North Coast Regional Water Quality Control Board

Subject: **Notice of Violation No. 2 and Response to August 26, 2016 Letter Regarding 13267/Cleanup and Abatement Order No. R1-2016-0031 (CAO) Requirements**

File: Douglas and Heidi Cole, Marble Mountain Ranch, 92520 Highway 96, Somes Bar; Siskiyou County APN 026-290-200, Klamath River Watershed, WDID No. 1A15024NSI

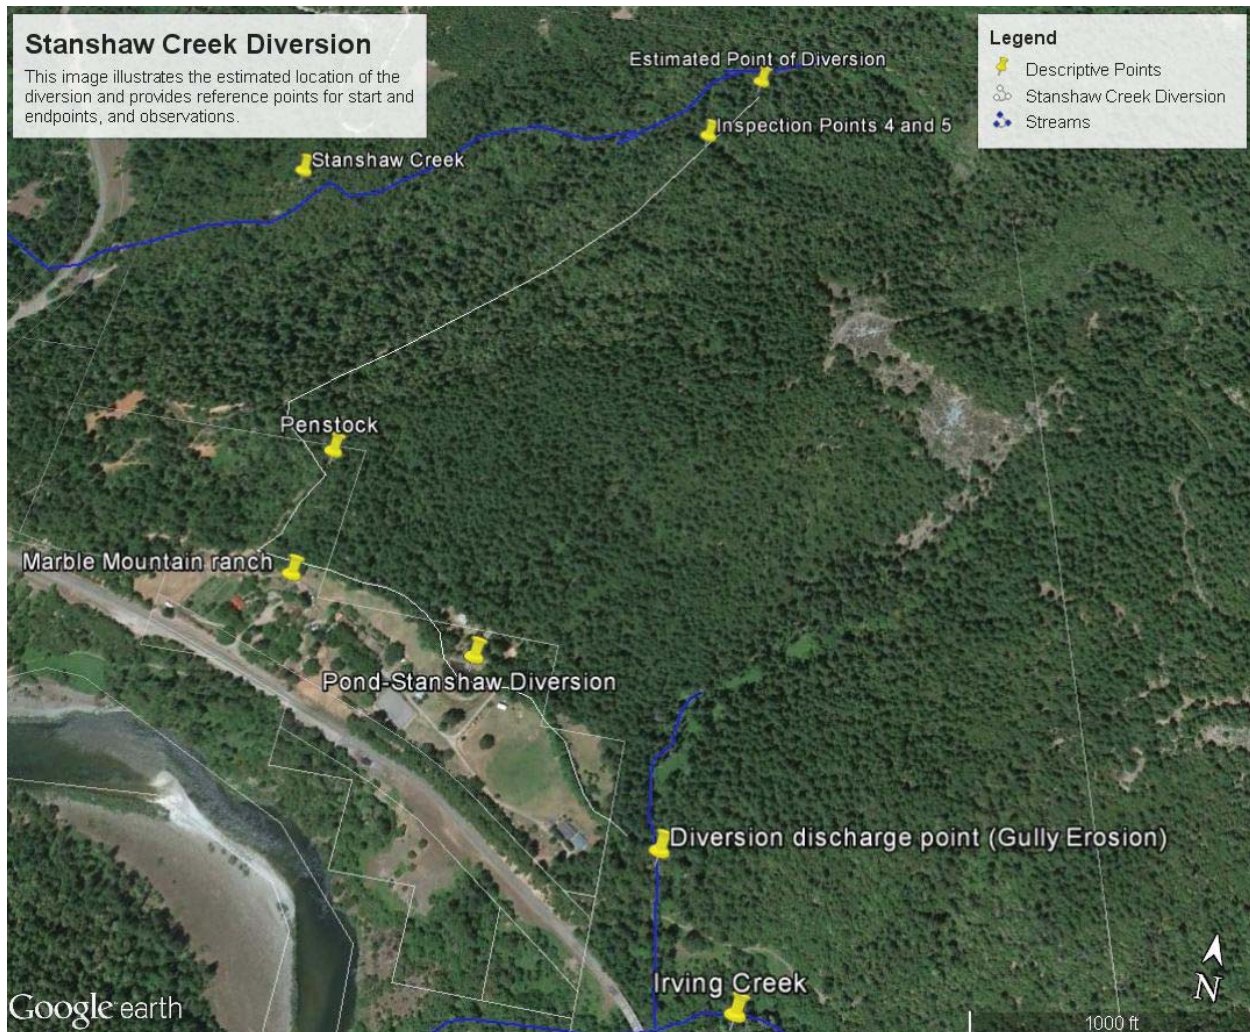
Image 1 provides general locations for the Point of Diversion at Stanshaw Creek (Point 1), and the discharge point above Irving Creek (Point 20), which are the start and end points of inspection observations as ordered below.

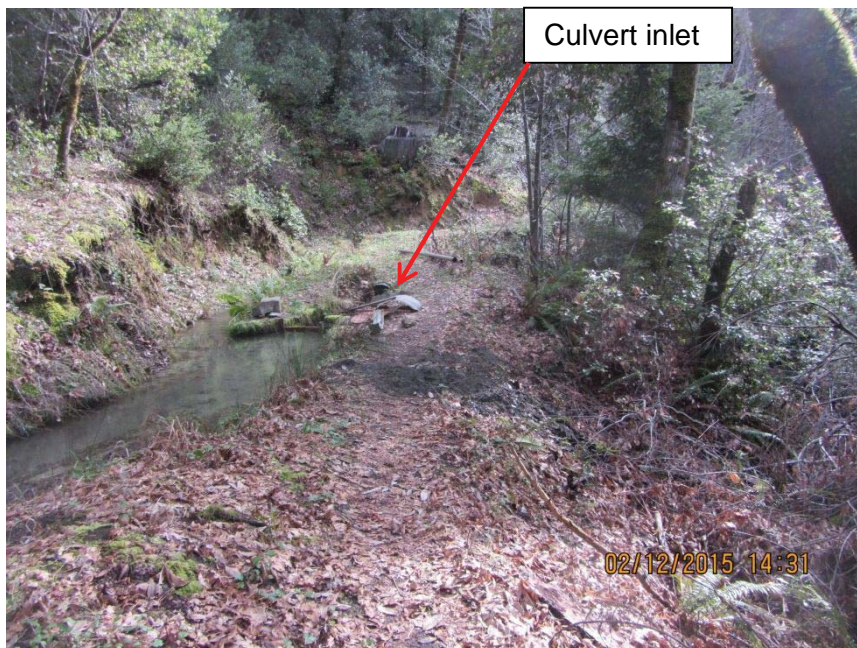
Image 10- at Point 4, shows a closer look at the seepage in the berm; note the muddy soils in the foreground. (Photo 8441 cropped)

Image 9- at Point 5, shows the shotgunned 12-inch ditch culvert outlet, diversion ditch and native stream channel flowing under the diversion ditch. (Photos 8442, 8443, 8444, 8445 composite)

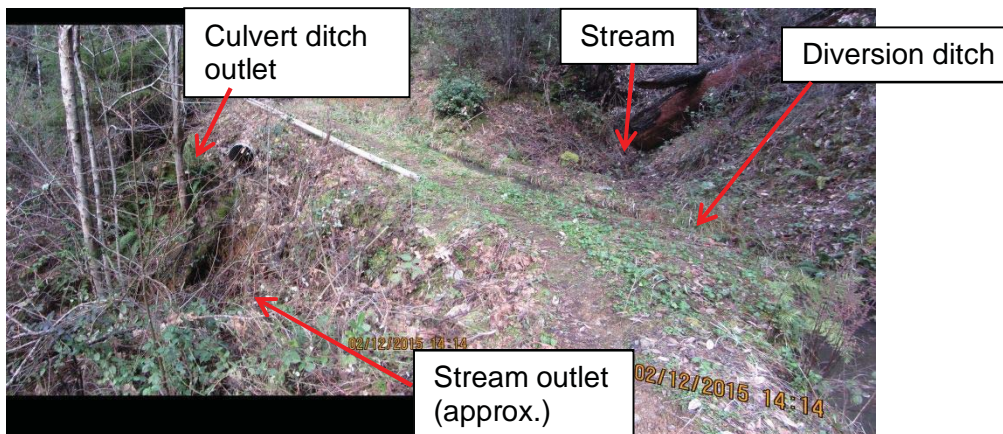
Image 10- shows the unnamed stream channel above Points 4 and 5; the upslope active bankfull stream channel width is approximately 3-4 feet.

For either alternative, the ditch repair or decommissioning plan shall include specifications to restore the affected stream/unnamed tributary that crosses at inspection points 4/5, replant with native vegetation, and to protect streams from any further impacts or discharges associated with the ditch.

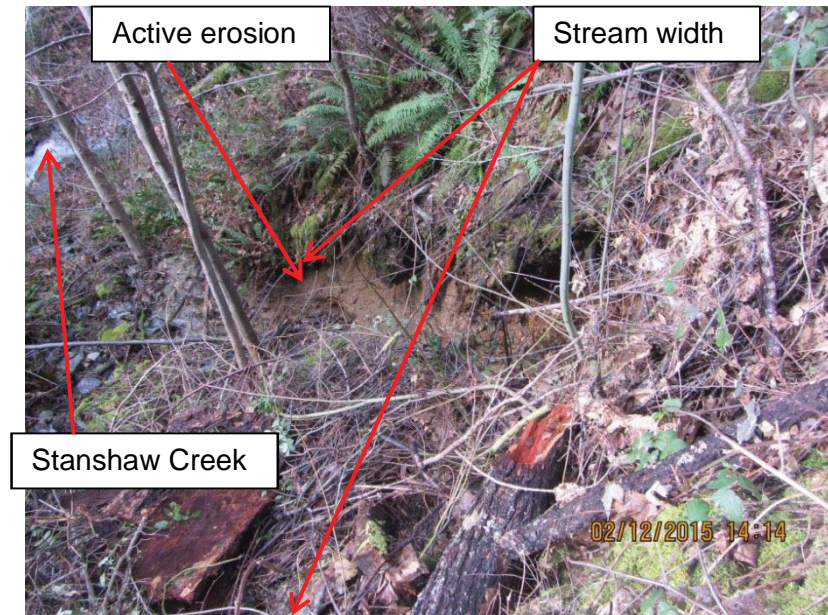
Image 12- shows Point 6, where the diversion channel is full, leaving no freeboard should it rain or the ditch receive a bank slump upstream. It appears the outboard berm may have failed in this area in the past, and at present is seeping, indicating that a portion of the berm may be saturated. Stanshaw Creek is within 200 feet; any failure here likely results in direct delivery of sediment and erosional debris. The flume section visible in the photo appears to have been installed to remedy previous ditch failures and/or to prevent future failures.

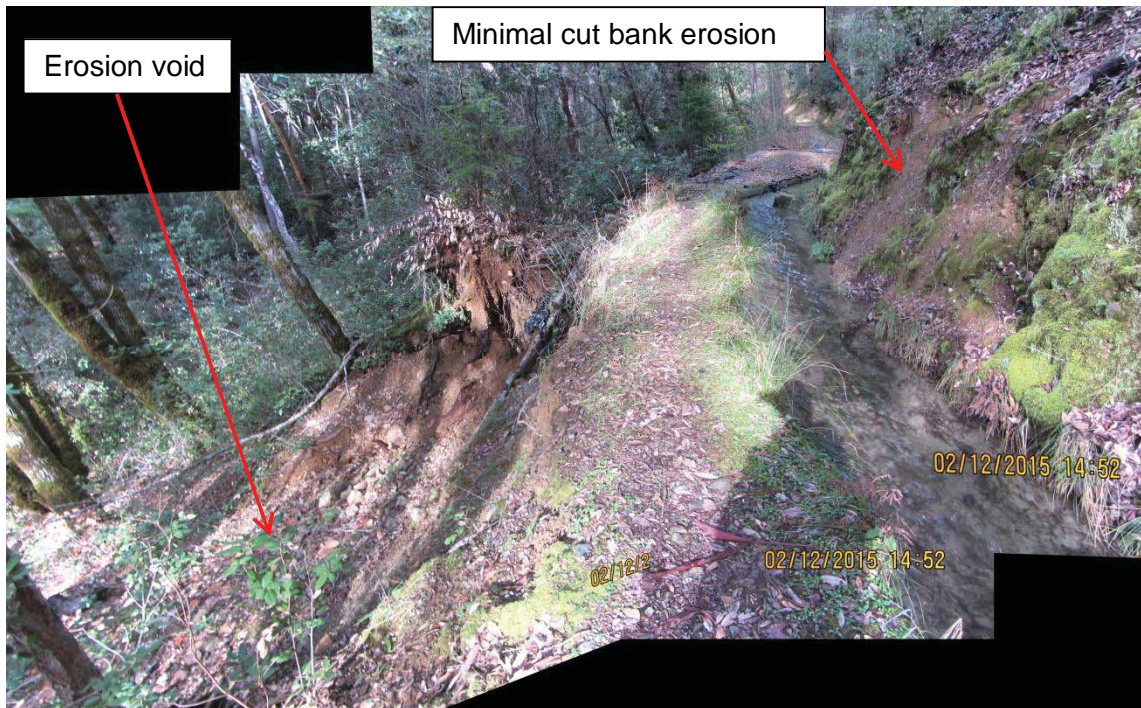
Image 17- Point 11 is another 150-200 feet of ditch with a low freeboard and evidence of past failures; this ditch segment leads to a section of ditch subject to a recent bank failure. I observed erosion scars on the lower slopes that are now overgrown with ferns and small shrubs. (Photo 8499)

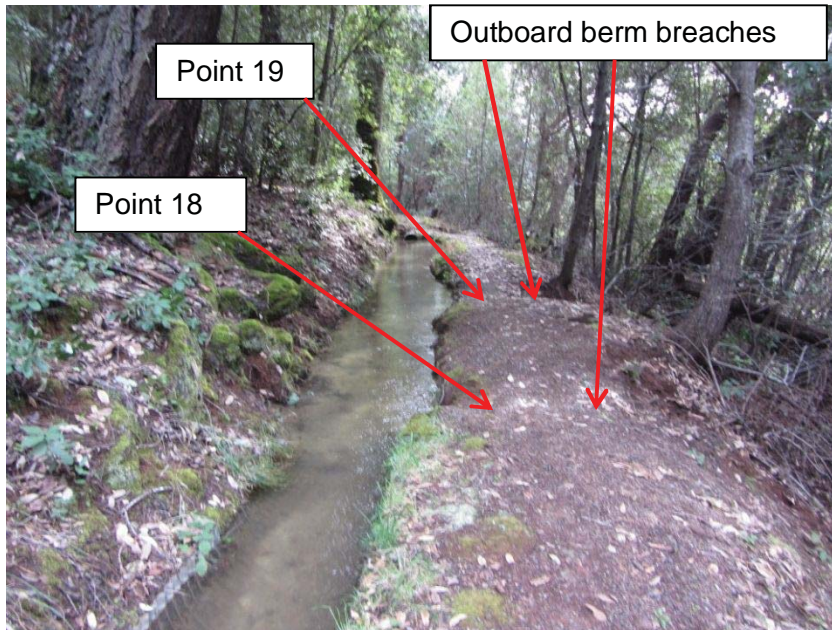
Image 26- Point 20 is the headcut upslope from Irving Creek. This is where tailwater from the Stanshaw Diversion is discharged to an unnamed stream, tributary to Irving Creek. This area is actively eroding. Several trees appear to have fallen recently through erosion of their root masses. I estimate that the headcut erosion has delivered between 1500-2200 yds³ of sediment to the Irving Creek watershed. (Photo 8529)

Figure 1. Project Location Map. Marble Mountain Ranch and the Stanshaw Creek Diversion Ditch. Base image is a 2010 1-meter LiDAR DEM Hillshade, provided by the Mid-Klamath Watershed Council.

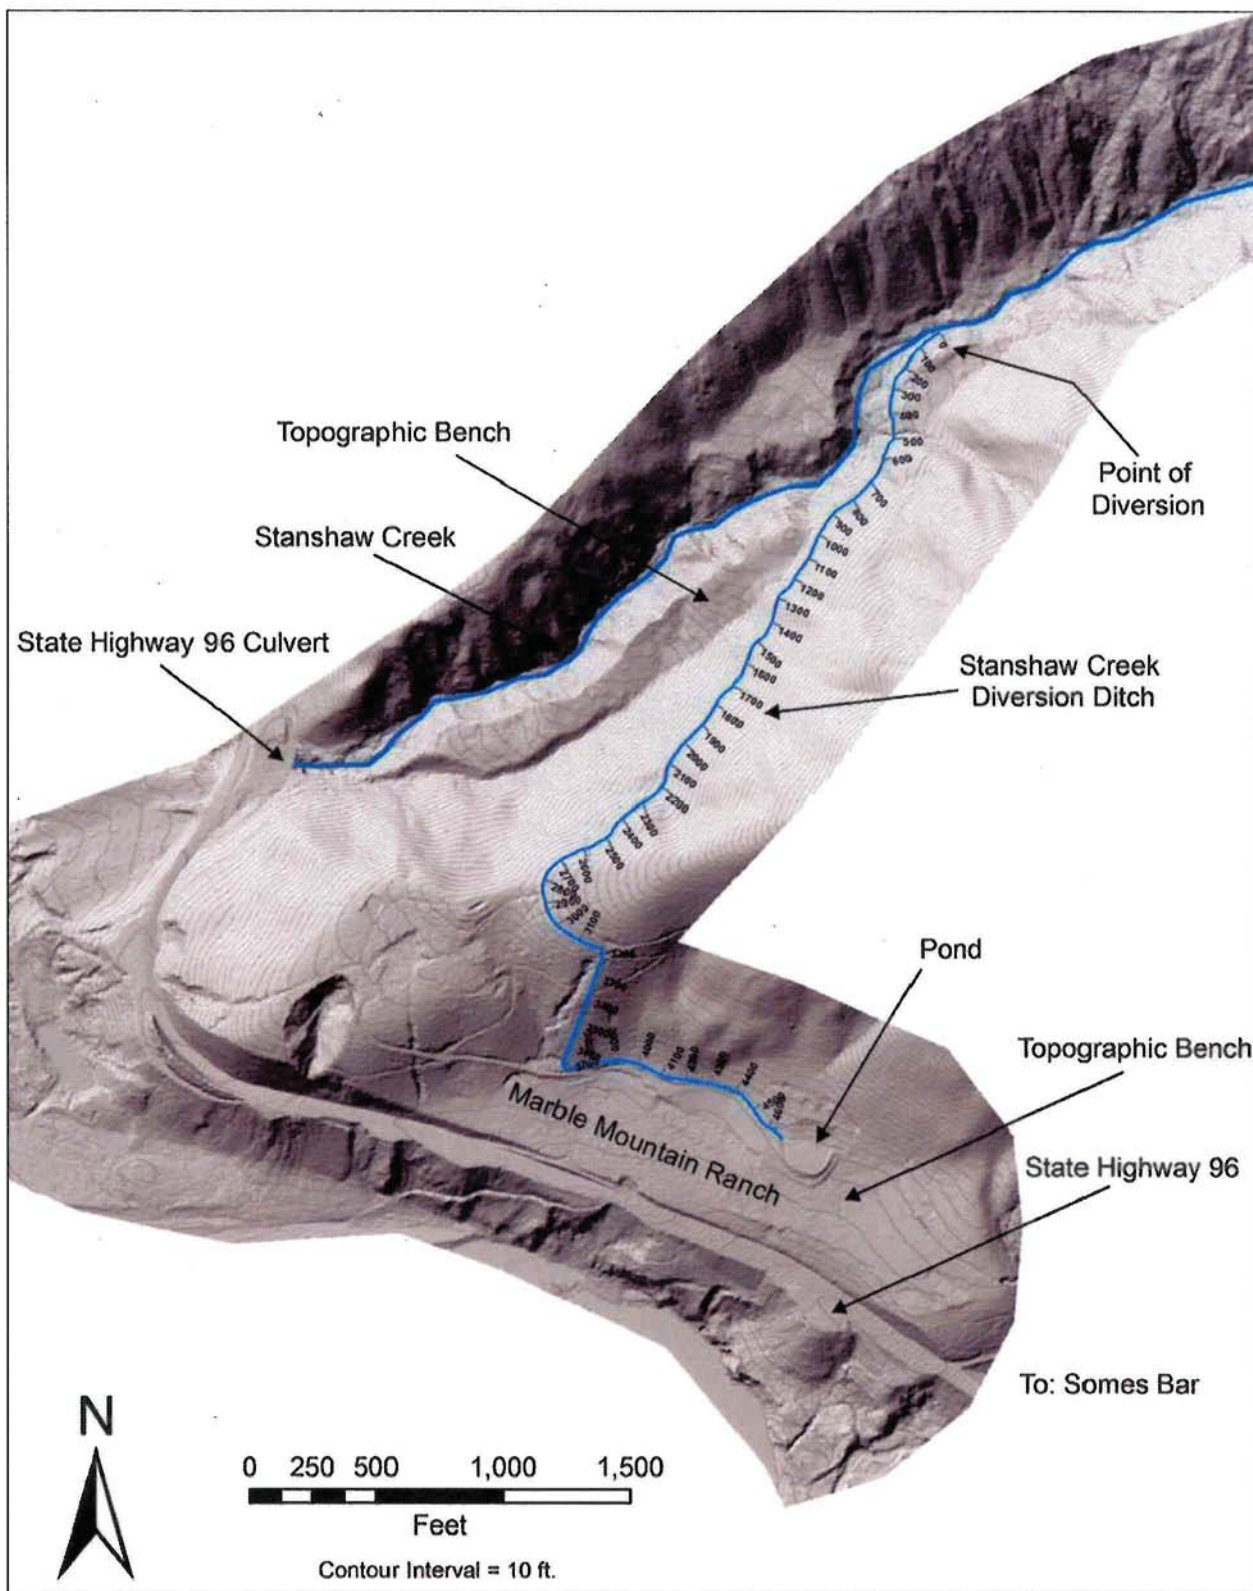
Based on my preliminary field observations and desktop analysis it appears the first 1100 feet (starting at the Point of Diversion) of the ditch has the greatest potential to deliver sediment to Stanshaw Creek in the event of a ditch failure. This is primarily because the ditch is located directly above the stream channel, and secondarily because the ditch is partially within the fluvial corridor of Stanshaw Creek (Figure 1). The remaining sections of the ditch have a low to moderate sediment delivery potential (Figure 1 and Table 1). The lower delivery ratings are due to the capacity of large topographic benches and dense vegetation to intercept and store a majority of sediment before it can be delivered to the receiving waters of the State (Figure 1).

There is approximately 6,400 feet of streambank (2 X 3,200 ft.) on Stanshaw Creek between the Point of Diversion and the Highway 96 Culvert (Figure 1). A preliminary slope stability analysis indicates these slopes are marginally to highly un-stable. Wagner and Saucedo (1987) mapped the landform in this area as Qls (Quaternary Landslide), which also indicates a higher potential for slope instability. Slope failures along the lower reach of Stanshaw Creek are likely a greater source of sediment delivery compared to the features along the ditch described by Feiler (2015), and could create background sedimentation and turbidity levels that would likely overprint inputs emanating from a ditch related failure.

Figure 1. Project Location Map. Marble Mountain Ranch and the Stanshaw Creek Diversion Ditch. Base image is a 2010 1-meter LiDAR DEM Hillshade, provided by the Mid-Klamath Watershed Council.

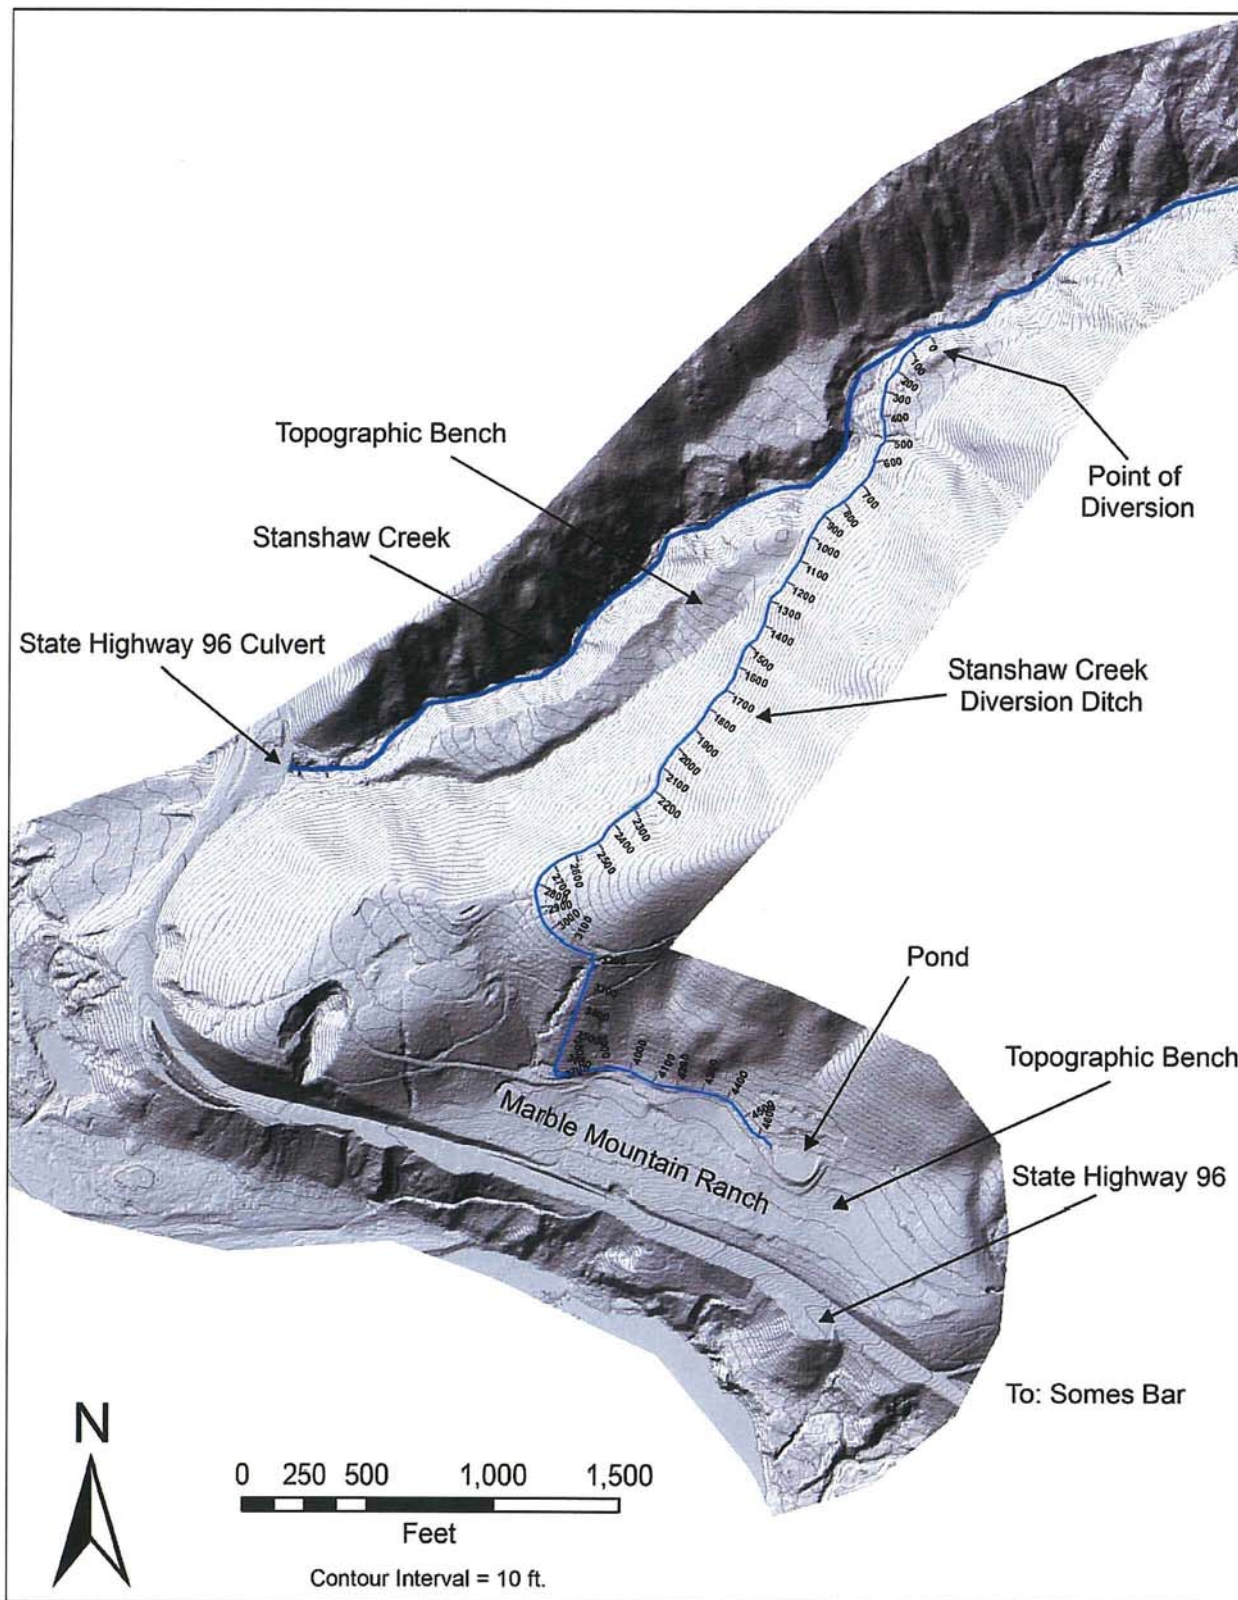
Based on my preliminary field observations and desktop analysis it appears the first 1100 feet (starting at the Point of Diversion) of the ditch has the greatest potential to deliver sediment to Stanshaw Creek in the event of a ditch failure. This is primarily because the ditch is located directly above the stream channel, and secondarily because the ditch is partially within the fluvial corridor of Stanshaw Creek (Figure 1). The remaining sections of the ditch have a low to moderate sediment delivery potential (Figure 1 and Table 1). The lower delivery ratings are due to the capacity of large topographic benches and dense vegetation to intercept and store a majority of sediment before it can be delivered to the receiving waters of the State (Figure 1).

There is approximately 6,400 feet of streambank (2 X 3,200 ft.) on Stanshaw Creek between the Point of Diversion and the Highway 96 Culvert (Figure 1). A preliminary slope stability analysis indicates these slopes are marginally to highly un-stable. Wagner and Saucedo (1987) mapped the landform in this area as Qls (Quaternary Landslide), which also indicates a higher potential for slope instability. Slope failures along the lower reach of Stanshaw Creek are likely a greater source of sediment delivery compared to the features along the ditch described by Feiler (2015), and could create background sedimentation and turbidity levels that would likely overprint inputs emanating from a ditch related failure.
